### **EUCLID AND ROSECRANS WATER MAIN REHABILITATION PROJECT NO. 53051**

#### **ADDENDUM NO. 1**

SCALE: AS NOTED SHEET 2 of 6 SHEETS

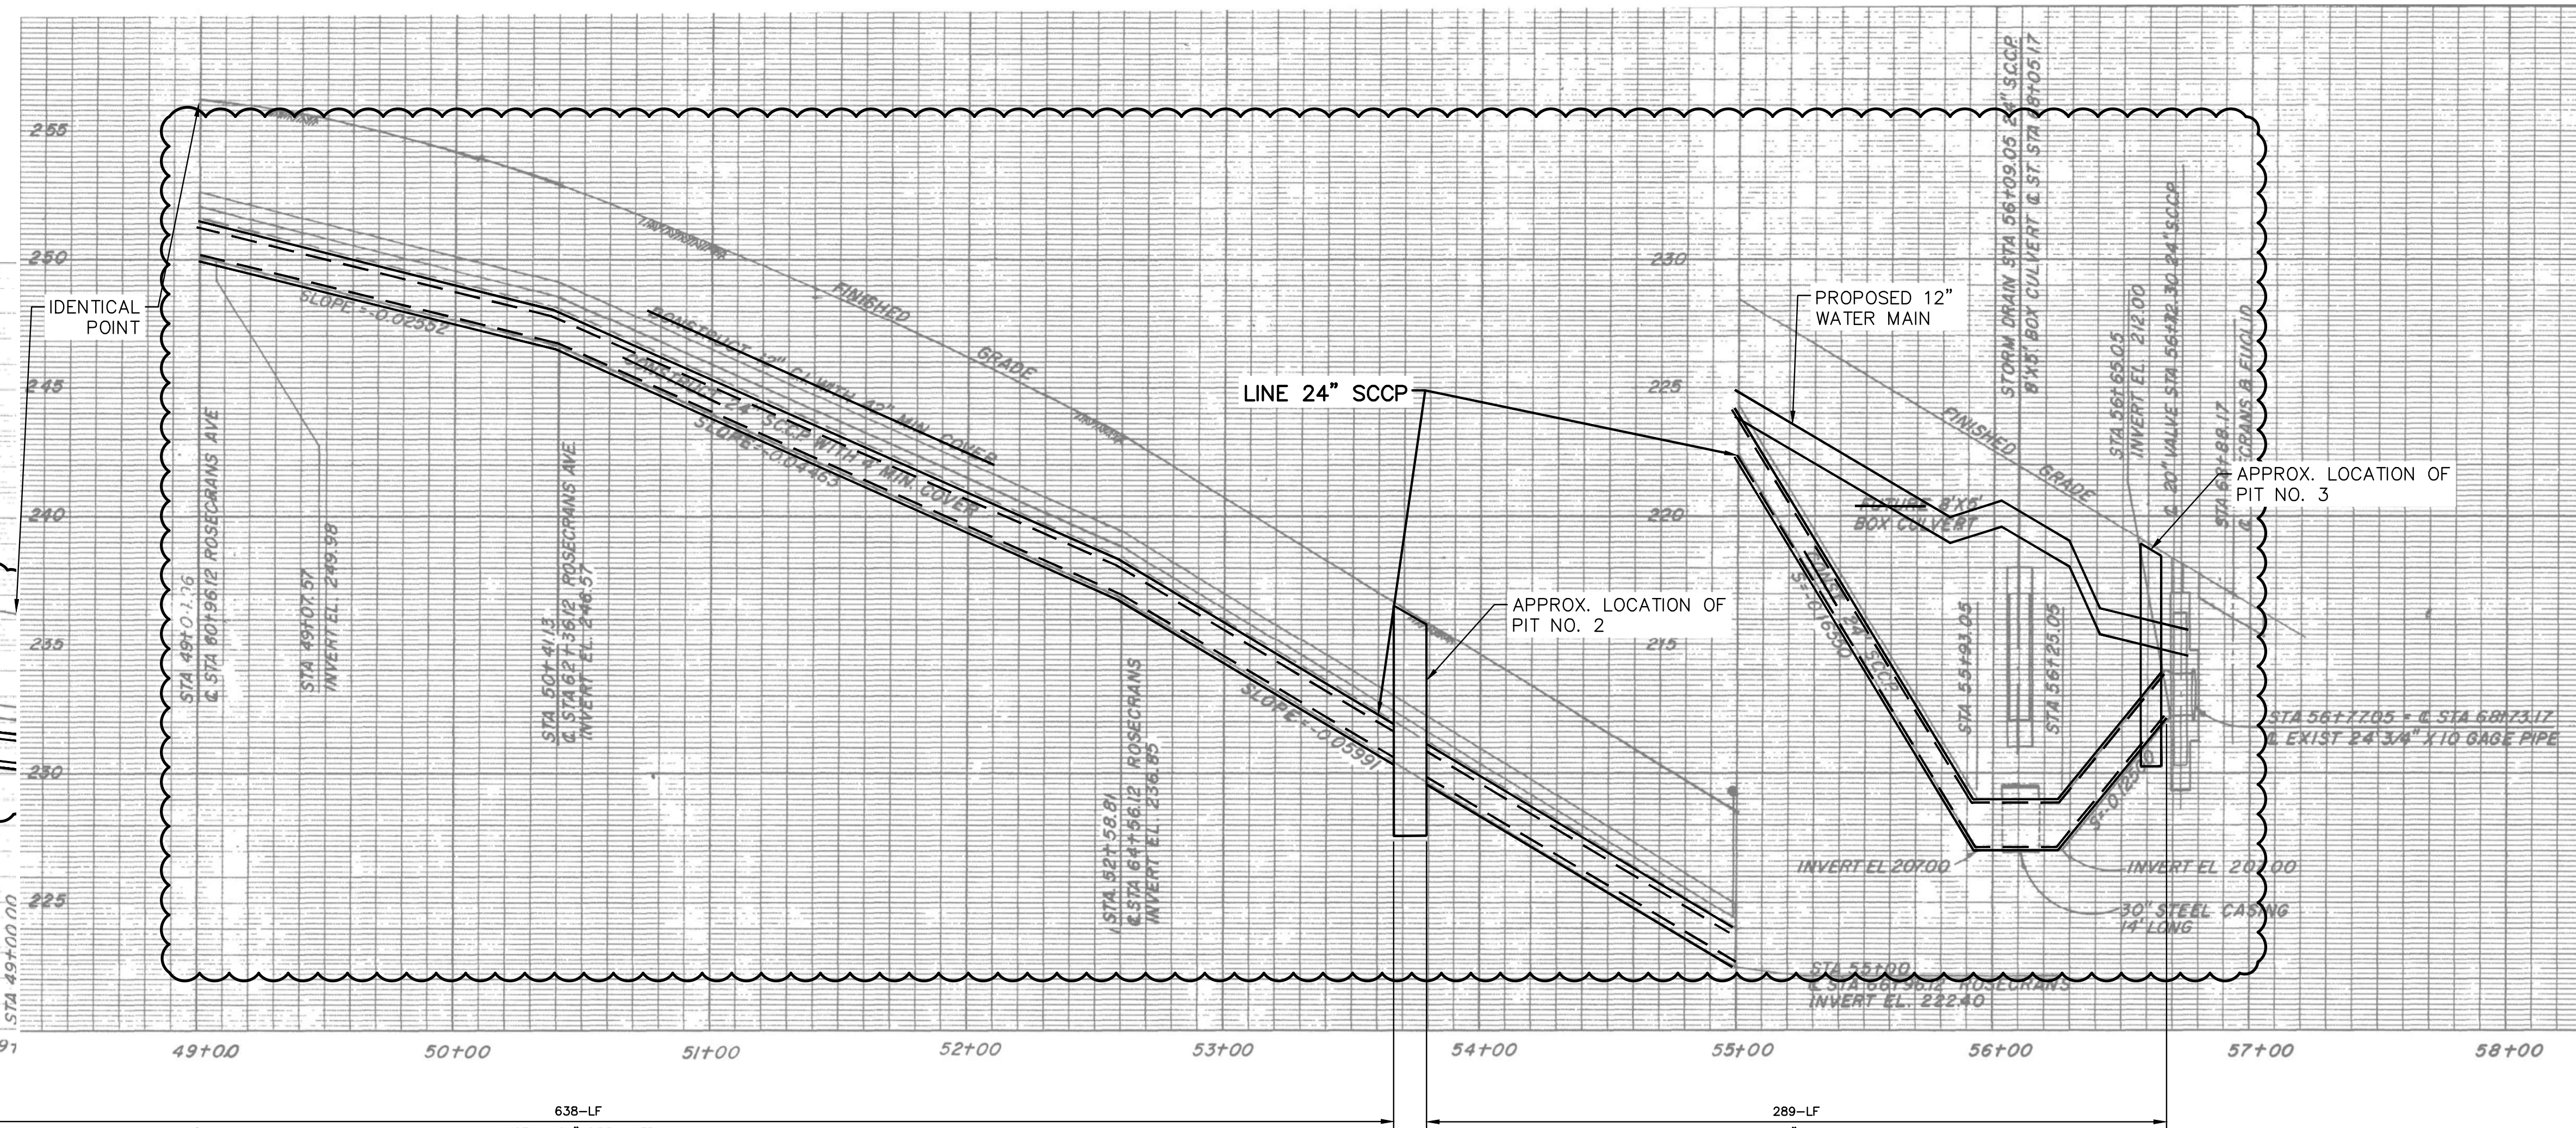
Sheet 2 is replaced with the attached Rev. 1 to Sheet 2.

| REVISIONS |                                      | DATE      | INITIALS    | DATE                     |
|-----------|--------------------------------------|-----------|-------------|--------------------------|
| 1         | UPDATED 2" SERVICE CONSTRUCTION NOTE | 4/15/2024 | FC/ED<br>MK | 10/02/2023<br>10/02/2023 |

- P- PROTECT IN PLACE
  - W34- REINSTATE 2" SERVICE IN LINING.
